SCHEDULE OF AMENDMENTS:

PLANS APPROVED BY THE LAND AND ENVIRONMENT COURT OF NSW

DATE	DEC 2024	NORTH	
DRAWN	JS	CHECK	NL
SCALE	1:200 @A1 Sheet Size		
DWG NO.	DA-101	ISSUE	8
STATUS	ISSUE FOR SECTION 4.55	JOB NO.

Sheet set out 1:200 @ A1

DRAWING
Basement 03 plan

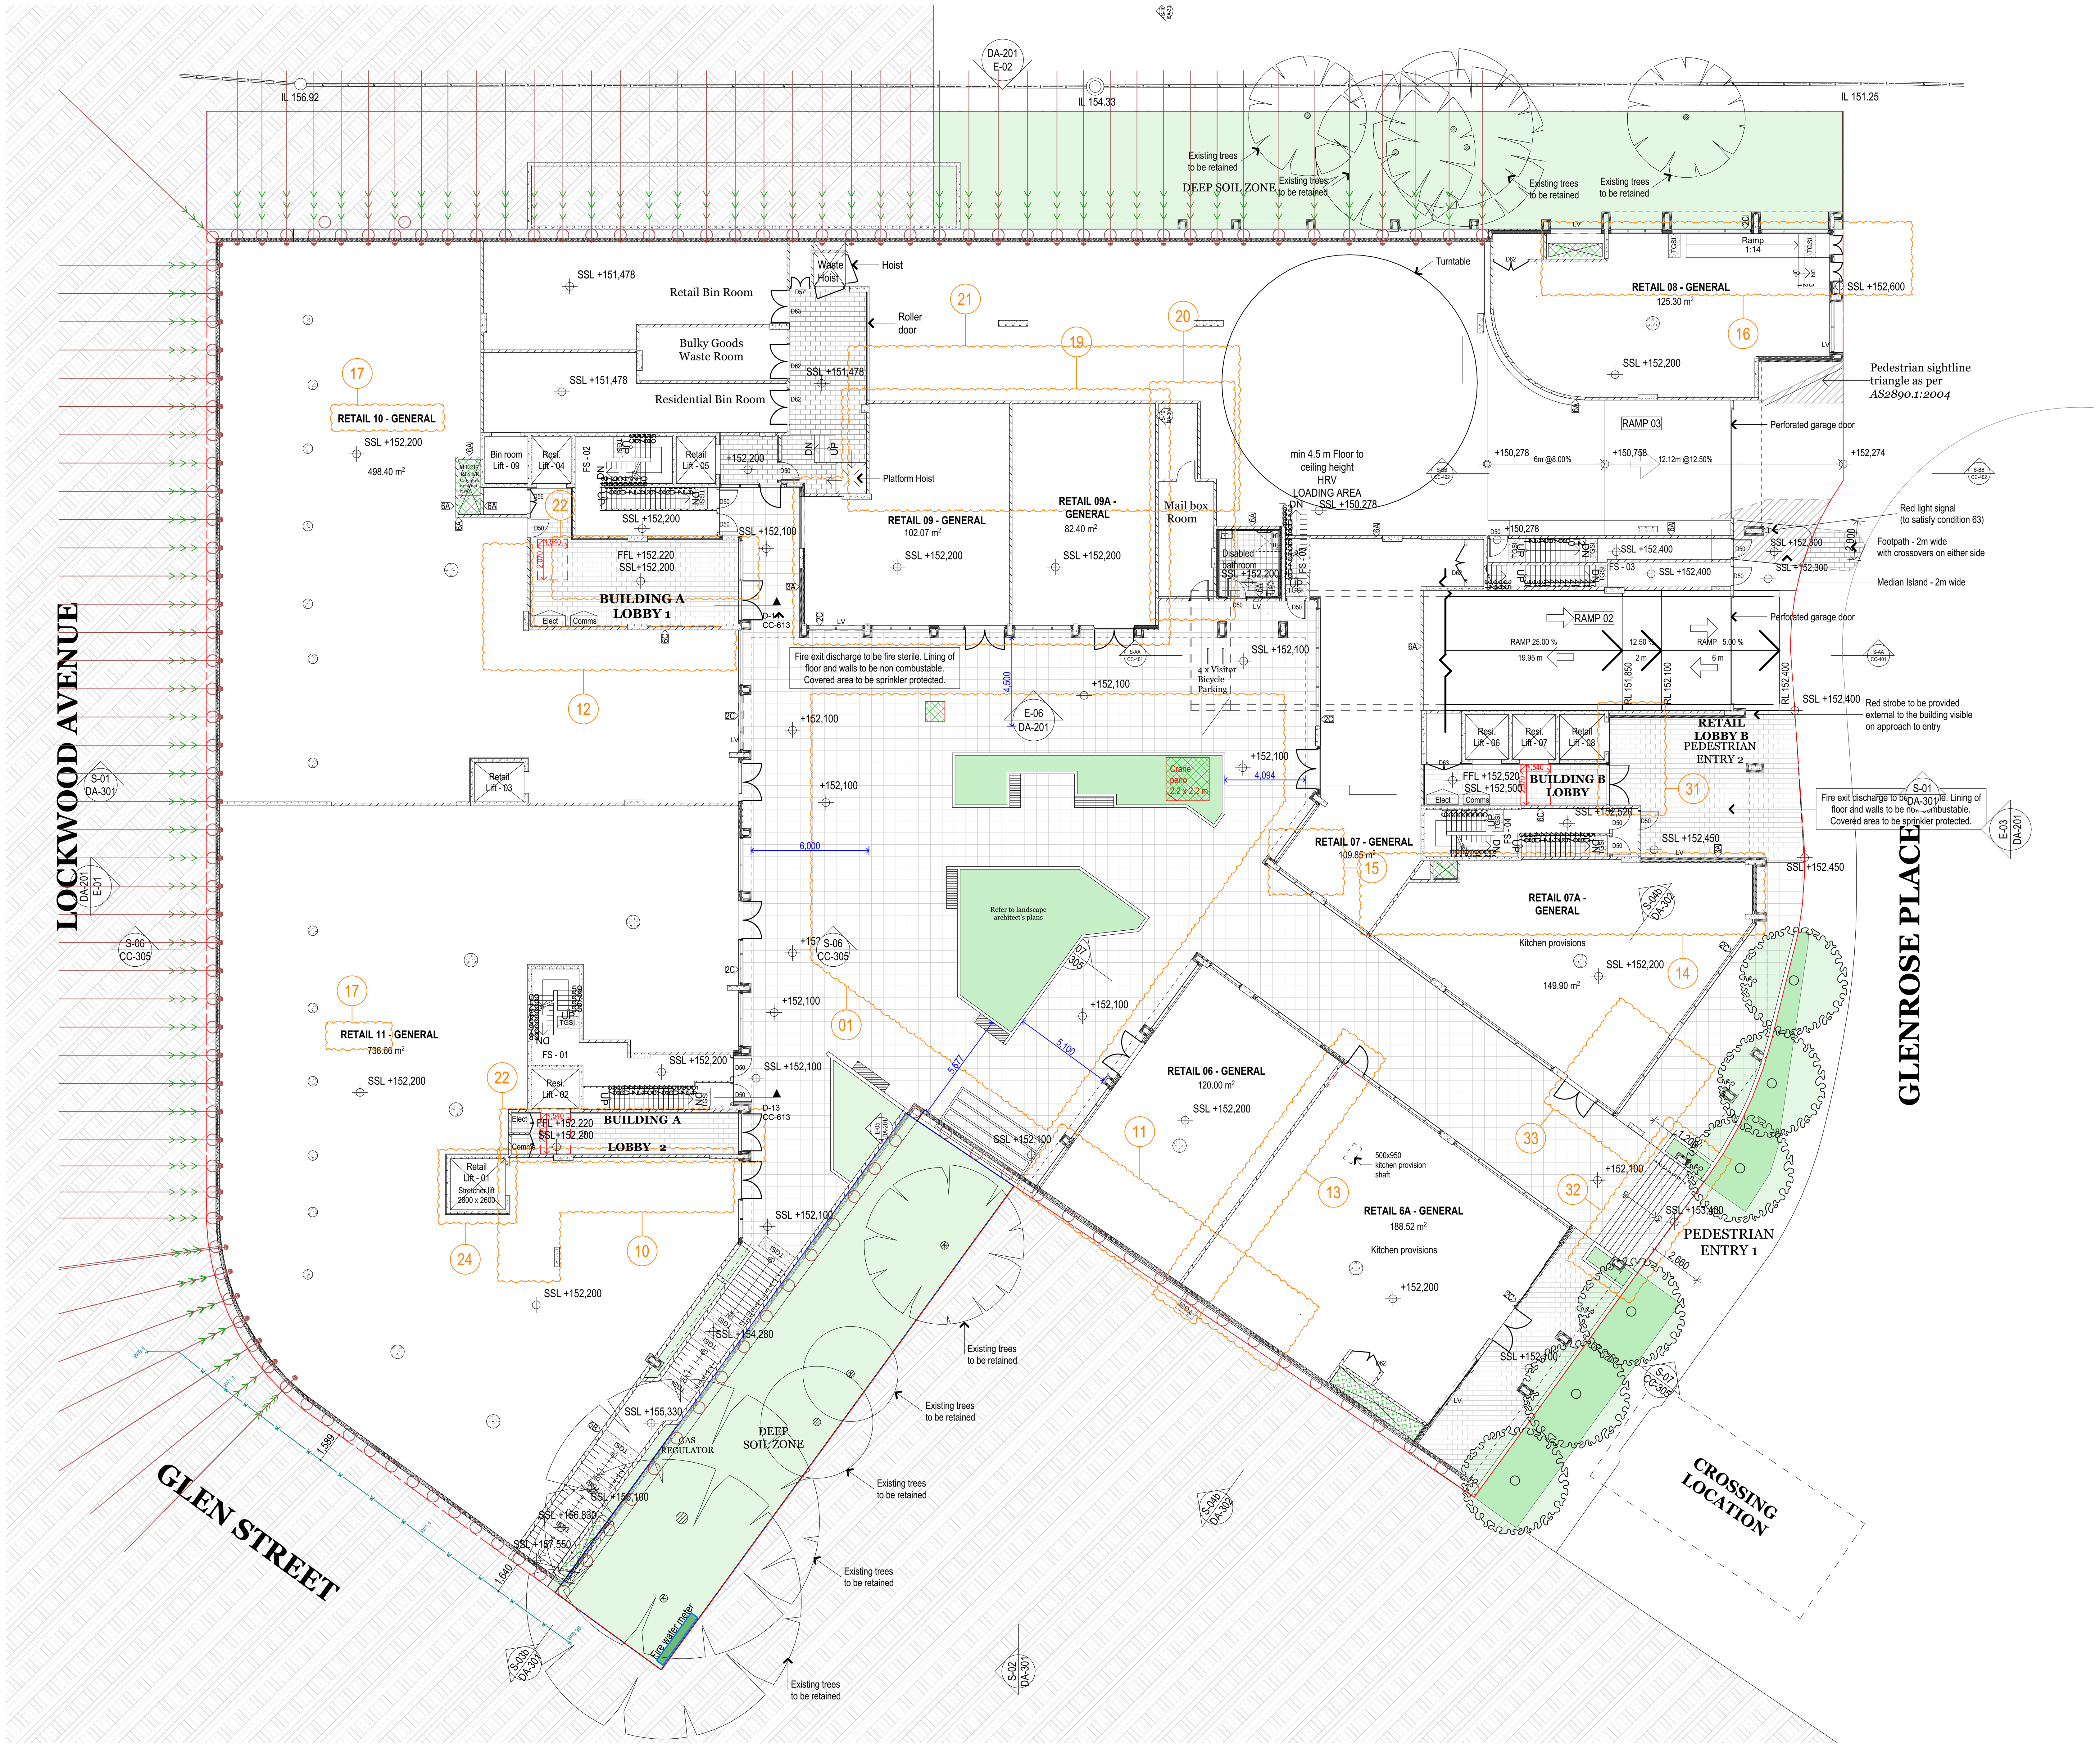
01- A re-design for the piazza levels and planter boxes.
02- Unit LG17 & G14: Layout reconfigured. The surface area has been increased by 60 m2 by combining two units (LG17 & LG18 - G14 & G15) of the previous layout and it is a 3 bedroom apartment with a study. (previously it was a 2 bed apartment & 1 bedroom apartment).
03- LG 18 & G15: Layout reconfigured. The surface area of this unit has been increased by 23 m2 and it is a 2 bedroom apartment with study.
04- Non trafficable roof added over unit G15.
05- This corner of Level 01 terrace has been extended over the balcony of unit G14 to act as a cover.
06- Unit LG07: The surface area has been increased by 91.3 m2 by shifting the communal room to the left to gain more area within the unit and by reducing retail 03 by 91.3 m2.
07- Unit 1.04: Layout reconfigured. The surface area of this unit has been increased by 24 m2 and it is a 3 bedroom apartment with study. (previously it was a 2 bed apartment).

08- Unit LG10: A coutyard has been added to its balcony and a planter box to act as a privacy screen for this unit since it is just above the natural ground level.
09- Unit LG11: The balustrading on the balcony has been replaced by a glass wall of 3 panel sliding window and fixed glass to 1 m height.
10- Retail 11: Ramp is removed.
11- Retail 06: Ramp is removed.
12- Retail 10: Ramp is removed.
13- Retail 06 has been split into 2 retails: 6 and 6A. And consecutive areas of 120m2 and 188.5m2.
14- Retail 07 has been split into 2 retails: 7 and 7A. With a separate entry ramp to retail 7A. And consecutive areas of 109.8m2 and 156.6m2.
15- The stairs in retail 07 has been deleted.
16- The external RL of retail 08 has been dropped down by 150mm after a review of the survey plan and the ramp in this retail has been adjusted and a stair is proposed.
17- Retail 03 has been split into 3 retails accross the three levels: retail 03 on ground floor, retail 12 on lower ground floor and retail 10 on basement 02 floor.

Retail 05 has also been split into 3 retails accross the three levels: retail 05 on ground floor, retail 13 on lower ground floor and retail 11 on basement 02 floor.
18- The void space which is adjacent to retail 03 on ground floor level has been deleted again as approved by previous S4.55.
19- Retail 09 has been split into 2 retails: 9 and 9A. The ramp has been deleted. With consecutive areas of 109.3m2 and 89.8m2.
20- A mail box room for the whole building has been added beside retail 9A.
21- The loading dock area has been reduced to accomodate for two vehicles instead of three vehicles.
22- The stairs and ramps have been deleted in lobbies 1 and 2 in building A.
23- Amendments to configuration of unit 1.11 due to the lift 01 overrun encroachment.
24- Lift 01 to be a stretcher lift. Size as per manufacturer specifications.
25- The entry pedestrian ramp in retail 04 on ground floor has been shifted from the middle of the shop to one corner of it.

26- Extension of roof over unit 1.12
27- Unit LG01: The surface area has been increased by 71.5 m2 by reducing retail 13.
28- The fire water storage tank in basement 03 is deleted as it is no longer needed.
29- Two retail car spaces have been added on basement 04.
30- The plant equipments to be placed within the approved vertical louvered space on the roof.
31- The entry doors to retail lift 08 lobby have been removed as the lift can act as the security interface and the entry door of building B lobby has been relocated.
32- The entry stairs from Glenrose PL to the piazza are larger now and planter boxes has been added on its both sides.
33- The corner of retail 7A has been cut back to widen up the access for disability from Glenrose PL.
34- Privacy screens has been added to bedroom windows of units LG06 and G06.

DRAWING
SECTIONS

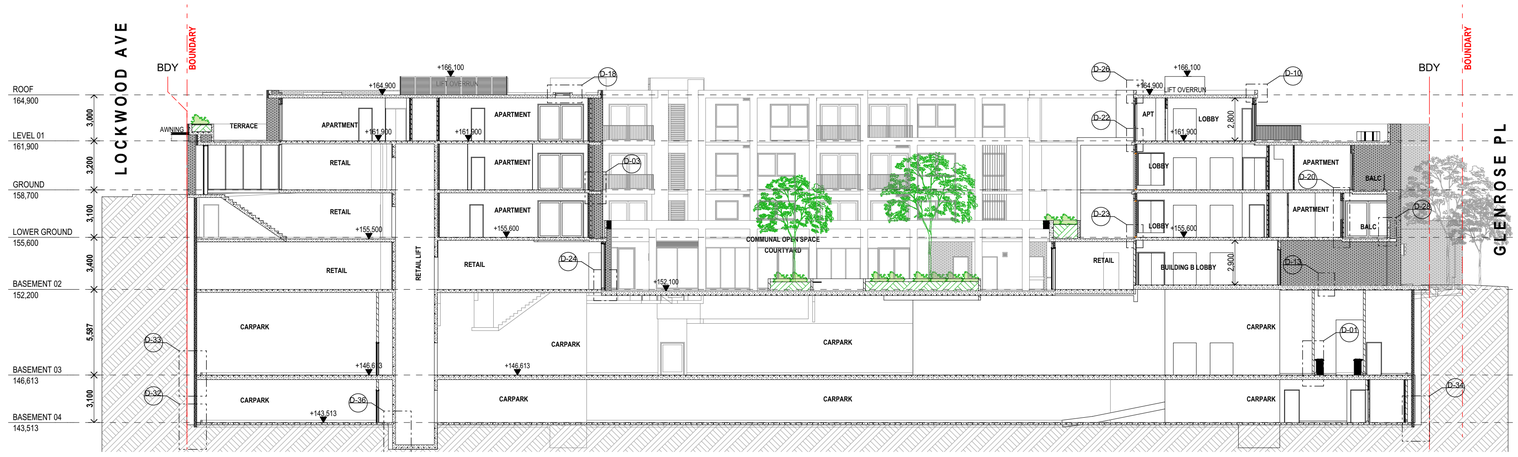
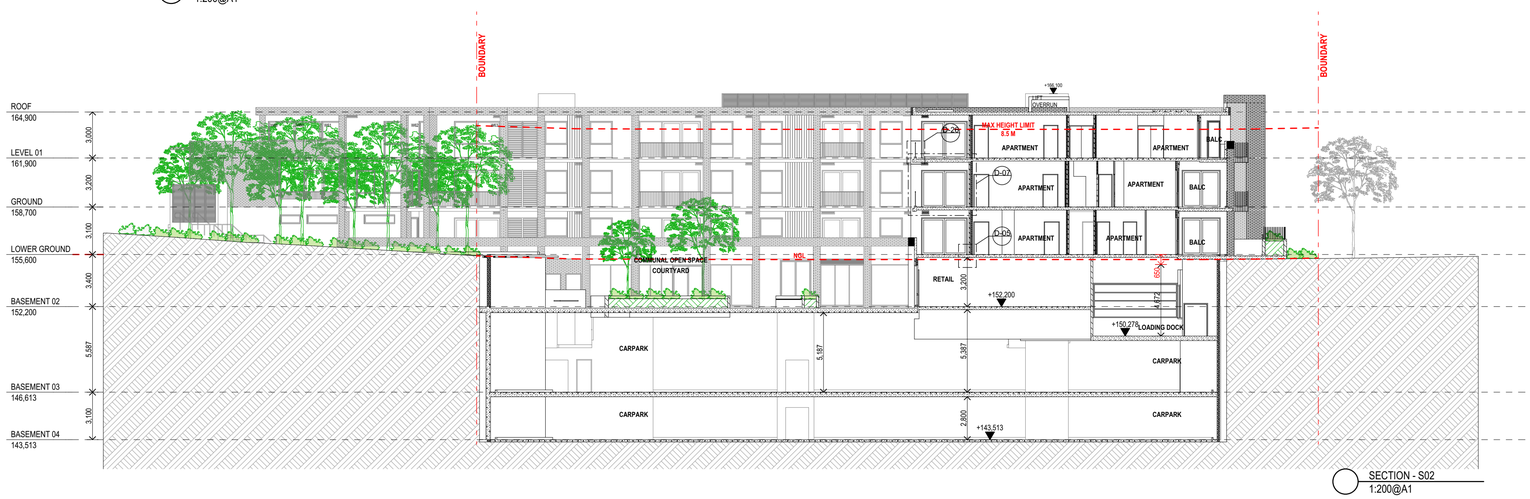
01- A re-design for the piazza levels and planter boxes.
02- Unit LG17 & G14: Layout reconfigured. The surface area has been increased by 60 m2 by combining two units (LG17 & LG18 - G14 & G15) of the previous layout and it is a 3 bedroom apartment with a study. (previously it was a 2 bed apartment & 1 bedroom apartment).
03- LG 18 & G15: Layout reconfigured. The surface area of this unit has been increased by 23 m2 and it is a 2 bedroom apartment with study.
04- Non trafficable roof added over unit G15.
05- This corner of Level 01 terrace has been extended over the balcony of unit G14 to act as a cover.
06- Unit LG07: The surface area has been increased by 91.3 m2 by shifting the communal room to the left to gain more area within the unit and by reducing retail 03 by 91.3 m2.
07- Unit 1.04: Layout reconfigured. The surface area of this unit has been increased by 24 m2 and it is a 3 bedroom apartment with study. (previously it was a 2 bed apartment).

08- Unit LG10: A coutyard has been added to its balcony and a planter box to act as a privacy screen for this unit since it is just above the natural ground level.
09- Unit LG11: The balustrading on the balcony has been replaced by a glass wall of 3 panel sliding window and fixed glass to 1 m height.
10- Retail 11: Ramp is removed.
11- Retail 06: Ramp is removed.
12- Retail 10: Ramp is removed.
13- Retail 06 has been split into 2 retails: 6 and 6A. And consecutive areas of 120m2 and 188.5m2.
14- Retail 07 has been split into 2 retails: 7 and 7A. With a separate entry ramp to retail 7A. And consecutive areas of 109.8m2 and 156.6m2.
15- The stairs in retail 07 has been deleted.
16- The external RL of retail 08 has been dropped down by 150mm after a review of the survey plan and the ramp in this retail has been adjusted and a stair is proposed.
17- Retail 03 has been split into 3 retails accross the three levels: retail 03 on ground floor, retail 12 on lower ground floor and retail 10 on basement 02 floor.

Retail 05 has also been split into 3 retails accross the three levels: retail 05 on ground floor, retail 13 on lower ground floor and retail 11 on basement 02 floor.
18- The void space which is adjacent to retail 03 on ground floor level has been deleted again as approved by previous S4.55.
19- Retail 09 has been split into 2 retails: 9 and 9A. The ramp has been deleted. With consecutive areas of 109.3m2 and 89.8m2.
20- A mail box room for the whole building has been added beside retail 9A.
21- The loading dock area has been reduced to accomodate for two vehicles instead of three vehicles.
22- The stairs and ramps have been deleted in lobbies 1 and 2 in building A.
23- Amendments to configuration of unit 1.11 due to the lift 01 overrun encroachment.
24- Lift 01 to be a stretcher lift. Size as per manufacturer specifications.
25- The entry pedestrian ramp in retail 04 on ground floor has been shifted from the middle of the shop to one corner of it.

26- Extension of roof over unit 1.12
27- Unit LG01: The surface area has been increased by 71.5 m2 by reducing retail 13.
28- The fire water storage tank in basement 03 is deleted as it is no longer needed.
29- Two retail car spaces have been added on basement 04.
30- The plant equipments to be placed within the approved vertical louvered space on the roof.
31- The entry doors to retail lift 08 lobby have been removed as the lift can act as the security interface and the entry door of building B lobby has been relocated.
32- The entry stairs from Glenrose PL to the piazza are larger now and planter boxes has been added on its both sides.
33- The corner of retail 7A has been cut back to widen up the access for disability from Glenrose PL.
34- Privacy screens has been added to bedroom windows of units LG06 and G06.
